A1 Birtley to Coal House

7.5C Statement of Common Ground: Environment Agency

**STATEMENT OF COMMON GROUND: ENVIRONMENT
AGENCY**

Regulation Number:	Rule 8 (1) (e)
Planning Inspectorate Scheme Reference	TR010031
Application Document Reference	7.5C
Author:	A1 Birtley to Coal House Project Team, Highways England

Figure 1: URBEXT Map

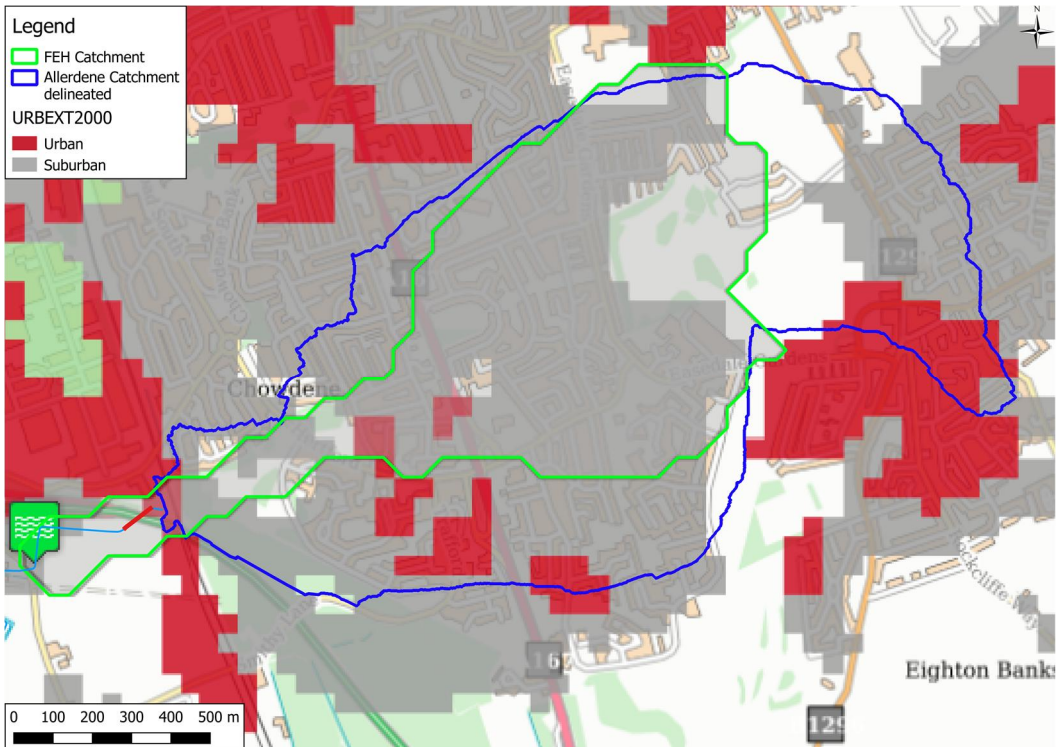
The catchment area has been delineated in GIS and has been compared to the URBEXT coverage, both of which are shown in Figure 1. The catchment descriptors have been updated in line with the identified change in catchment area, these are documented in Table 1

Figure 2 ReFH2 Growth Curves

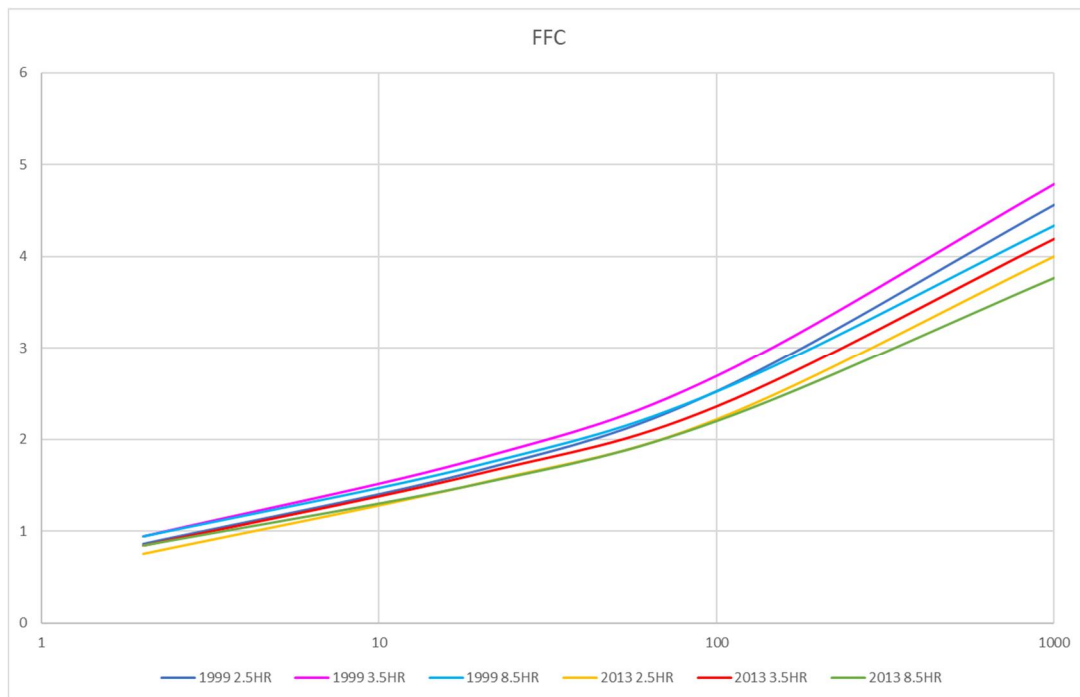
The ReFH2 derived flows have been recalculated (within the ReFH2 software v2.2 and not within ICM) with the refined catchment descriptors as detailed in A-6, the revised flows are detailed in Table 2 and the growth curves in Figure 2, both are below, the key aspects / findings are:

Figure 3: J66 Flood Depths for the 1 in 100 year (1%) event

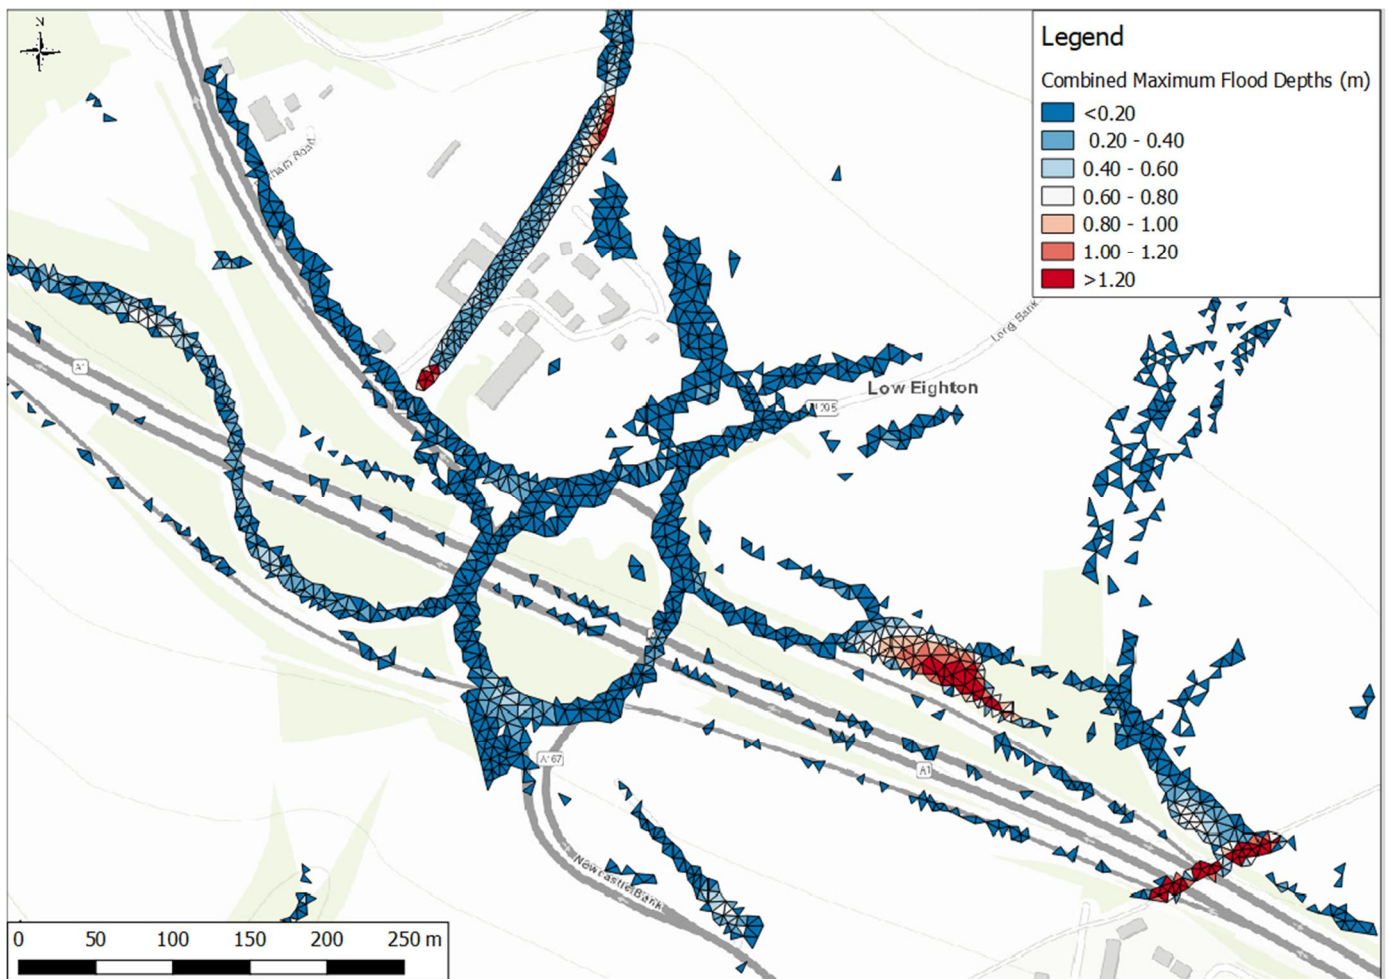
the area of interest. However, as requested all the durations have been run and the results merged to obtain the greatest flood depths. The resultant 1 in 100 year flood map is shown on Figure 3.

Figure 4: Improvements to channel and left bank flows for the Kingsway Viaduct river reach (TEAM_5156.1) because of lowering the bank modular limits to 0.6 (option model)

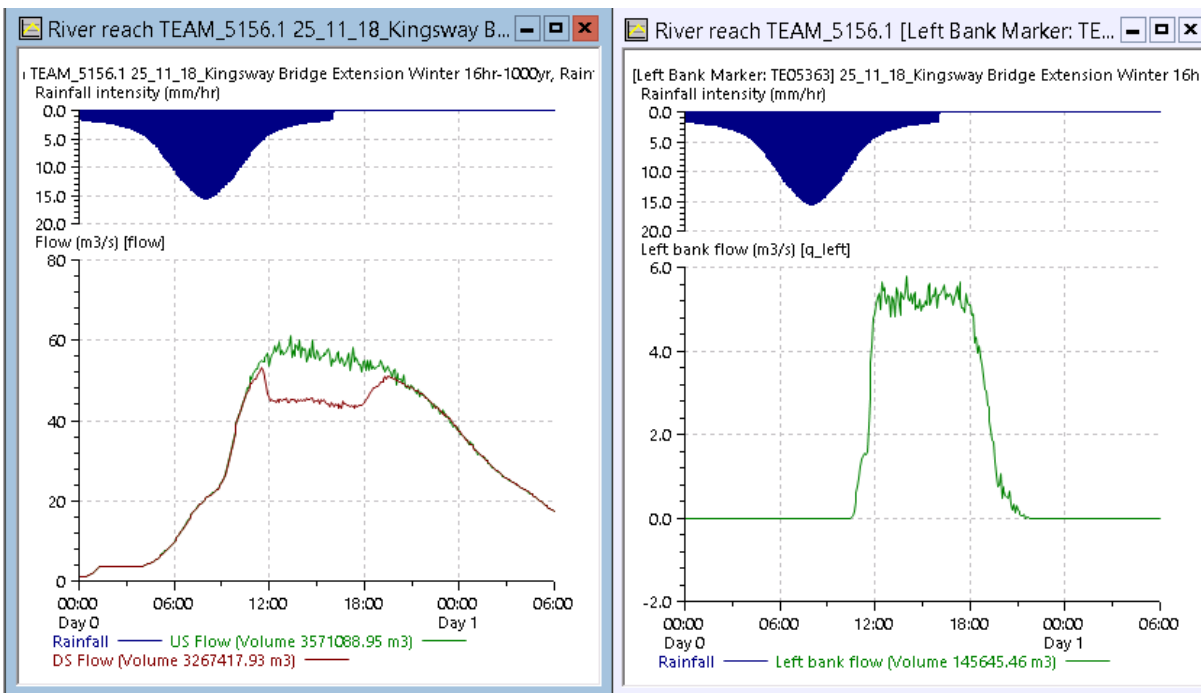
Lowering the bank line modular limit to 0.6 for the TEAM_5156.1 river reach improved left bank flow for the option model, as shown in Figure 4, but caused the original basemodel provided by the EA to fail. The change in modular limit had no impact on in channel flows. The stability problem seems to be a wider issue with the model for example, river reach TE05820.1 directly upstream of the Kingsway Viaduct, shown in Figure 5, shows significant oscillations to in channel and left bank flows. Resolving stability issues with the wider approved and provided Environment Agency model (as developed by JBA) is not required as part of

An attempt was made to improve channel conveyance of river reach TEAM_5156.1 however, this resulted in the model failing to run.

Figure 11: Flow hydrographs at river reach ST02 DS.1 for 1 in 100 year flows with varying roughness

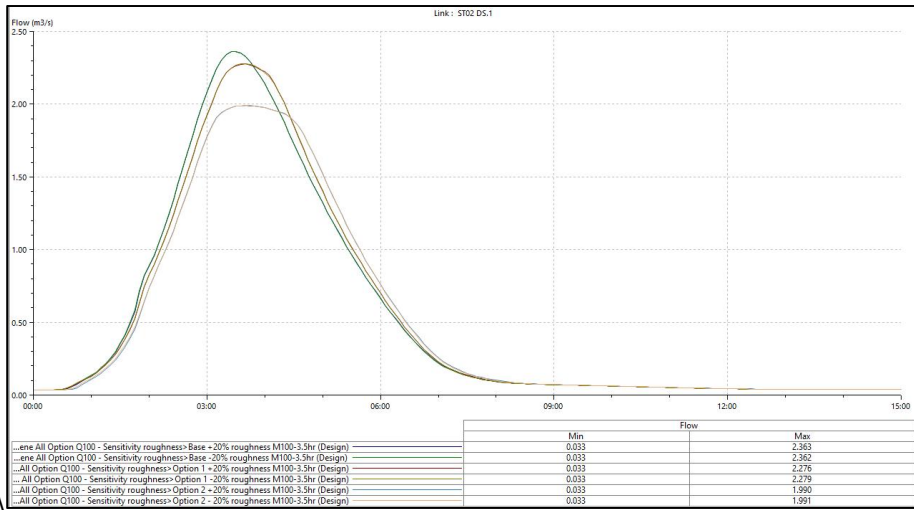
Increasing channel roughness by $\pm 20\%$ has no impact on peak flows (Figure 10). However, for channel depths it does cause the maximum depth to vary by approximately 140-150mm (Figure 11) or approximate ± 70 -80mm compared with the baseline roughness values. This is considered to be within the acceptable model tolerance limits.

Figure 3: Left bank flows at TEAM_5156.1

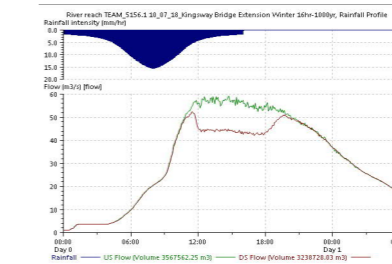
B-140	Total mass error = 9.9 m3	Acceptable		N/A
		B-141	Volume balance error = 0.9 %	Acceptable		N/A
		B-142	There is some oscillation in the peak flows in the area of interest during a 0.1% AEP event (Figure 2)	Minor issue	Make updates to conveyance and bank lines to improve stability	See response to B-29
		B-143	There is some significant oscillations in the out of bank flows in the area of interest during the 0.1% AEP event (figure 3)	Major issue	Make updates to conveyance and bank lines to improve stability. If appropriate, lower bank co-efficient	See response to B-29
Sensitivity testing	- Suitability of sensitivity testing undertaken - Results & interpretation of sensitivity testing	B-144	Sensitivity tests not provided for review	Minor issue	Run sensitivity tests	See response to B-137
Calibration / performance		B-145	No model performance testing was provided for review.	Minor issue	Use the model report to provide commentary on the sensibility of predicted flooding.	This is addressed within the accompanying technical note

Figure 3: Bank level miss match

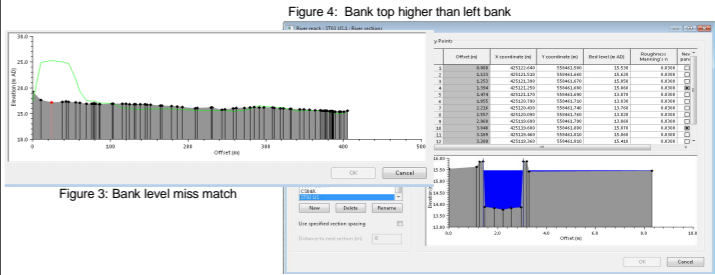
Scenarios	<ul style="list-style-type: none"> - Do minimum (baseline) - Do nothing - Do something 	B-45	Option 1b: Ditch realignment + flow control A Mesh Level Zone has been added over the existing watercourse, as before (for comments see Option 1a). Pipe size of SA02USc.1 has been reduced from 1.35 to 1.2m in diameter. No other apparent changes made from Option 1a so same comments stand.	Acceptable - but does not meet best practice		N/A
			B-46	Option 2: Viaduct A Mesh Level Zone has been added over the existing watercourse, as before (for comments see Option 1a). There is no apparent level change in the model to account for lowering the highway embankment which is present in the DTM JBA imported (no DTM provided). As a result, in some places there is a 9m miss match between the 1D and 2D bank levels modelled. In channel water levels do not exceed bank top during the 0.1% AEP so this is not impacting results. The open channel has been extended to replace the culvert. As per Option 1a, sections ARD1-ARD4 have lower left bank to the bank top (Figure 1). The same is true for ARD14-17 and ST02 US. Here channel flow does exceed bank top in the 0.1% AEP event (Figure 4) so this is impacting results. As per Option 1a, conveyance plots are kinked in at greater depths, which in this instance could impact the results as in channel depths exceed 1m.	Minor issue	Trim 1D cross sections to the highest point on the left bank. Update panel markers and channel roughness to smooth conveyance plots at deeper flows.	This is addressed within the accompanying technical note

Drawing figure 7.6 sheet 2b

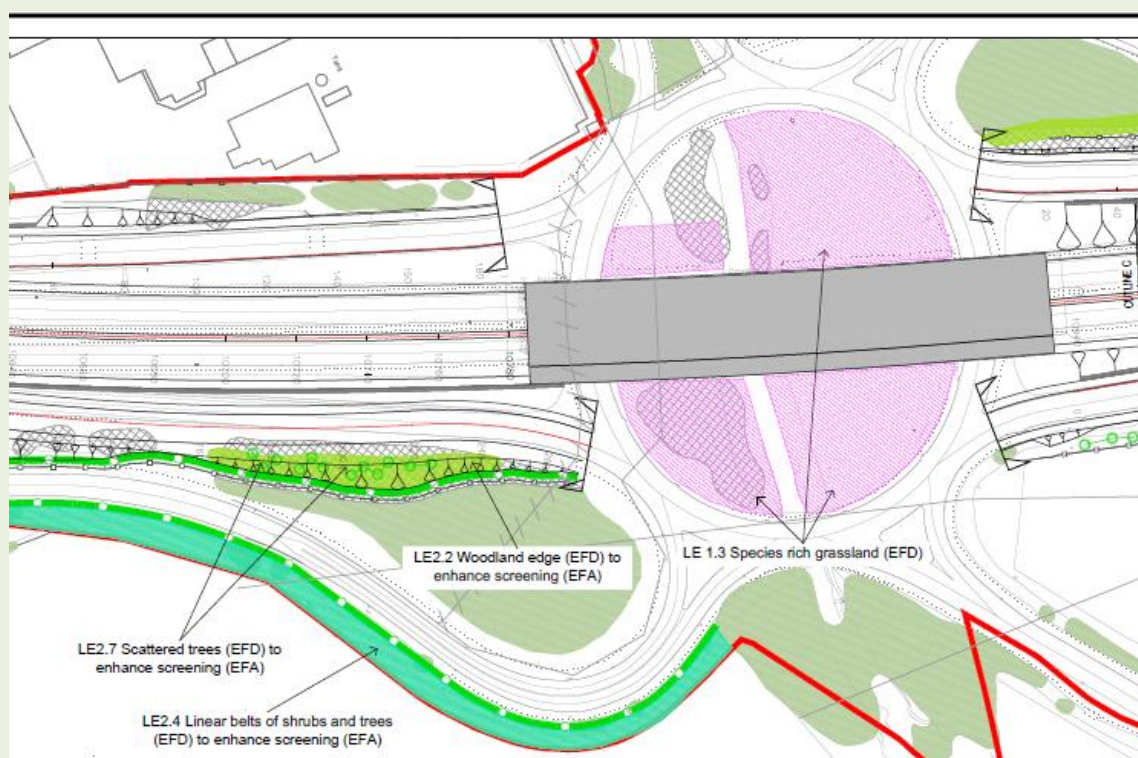
The Applicant must provide flood plain compensation for this new option. It is noted that landscape drawing figure 7.6 sheet 2b, shows no floodplain compensation being given – see drawing below. We would welcome further discussions regarding this matter.

3 Span Option

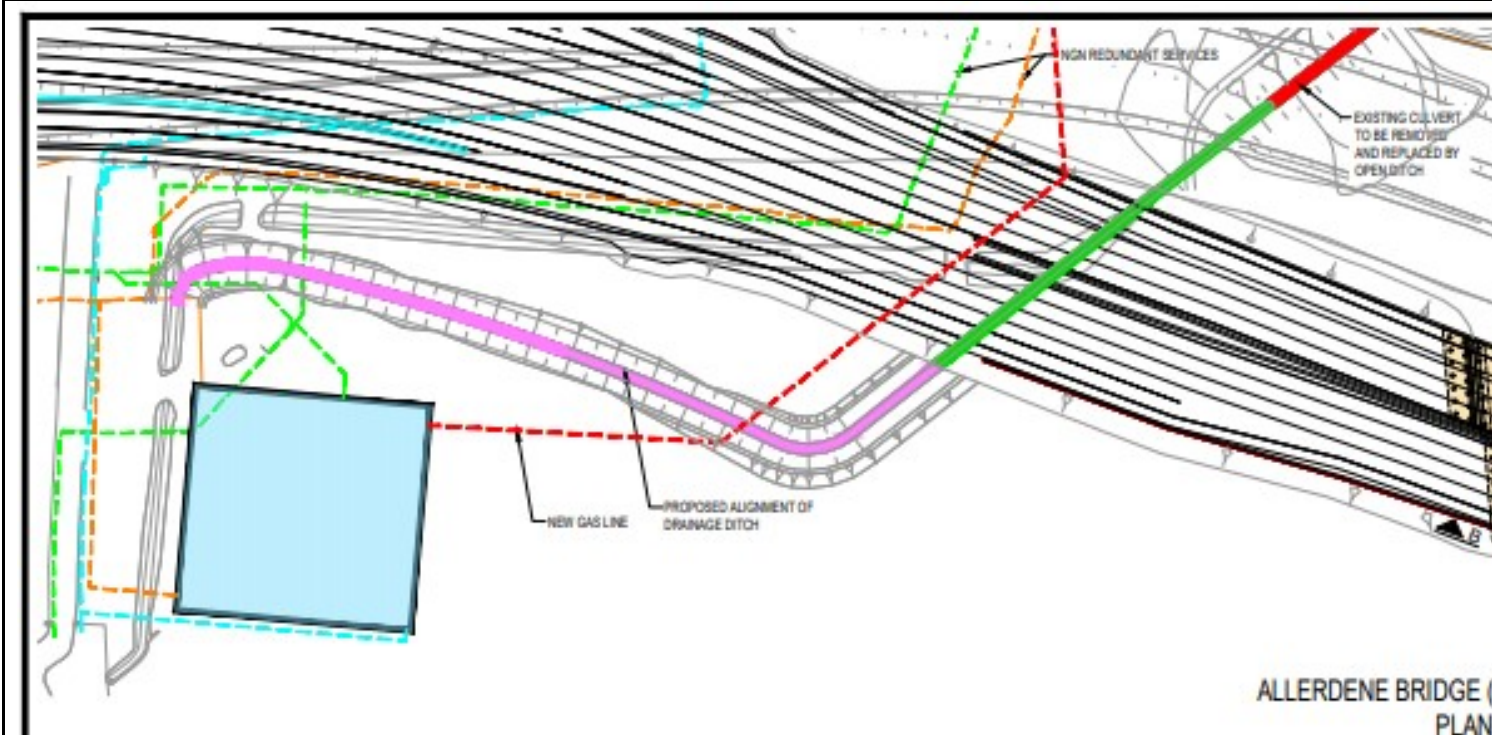
The drawings show that in terms of the Allerdene Burn there is marginal difference between the Embankment Option and the 3 Span Option (although there is some additional channel length for the 3 Span Option) and as we have agreed the works associated with the Allerdene Burn for the embankment option, I was surprised by some of the comments. For clarity the 3 Span Option is a viaduct over the east coast main line but not over the Allerdene Burn. As the two options (embankment and viaduct) have been presented equally in the past, with no preference stated between the 6/7 span or embankment option, the current option cannot be considered a backward step when compared to the assessment previously provided and agreed.

In light of this we do not consider that there is a need to provide additional WFD and biodiversity mitigation for the 3 span option given that the channel relocation is essentially the same as that agreed for the embankment option and likewise there is no requirement to undertake a carbon calculation for the Allerdene Burn as we have not completed this for the agreed designs.
